No: 97117-229  
Subject: AIRTEK AXLE GROUP CLAMP BOLTS  
Date: JUNE - 2011 Revision: B

1. The Airtek Axle Group clamp bolts, fitted to the IVECO 2350 Family of Vehicles, are currently configured with M20 bolts with a course 2.5 MM pitch thread. To reduce the dependency on maintenance these bolts are to be replaced with a M20 bolt with a fine 1.5 MM pitch. An additional lock nut is also to be fitted.

Figure One

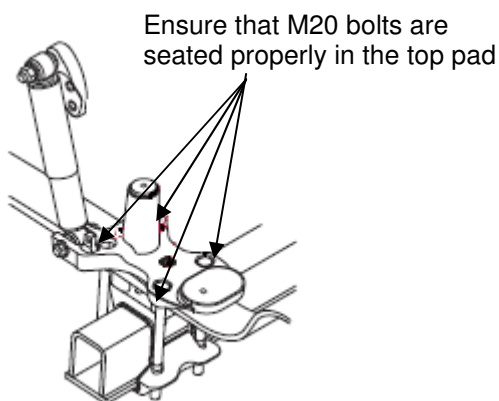
- d. Install the 3/4 inch lower shock mounting bolts, washer and locknuts and tighten to 320 N.m.
  - e. Ensure that the clamp group is properly aligned, the hex bolts are seated in the top pad and, the bottom axle wrap is centered with the top axle wrap. See Figures One and Two.
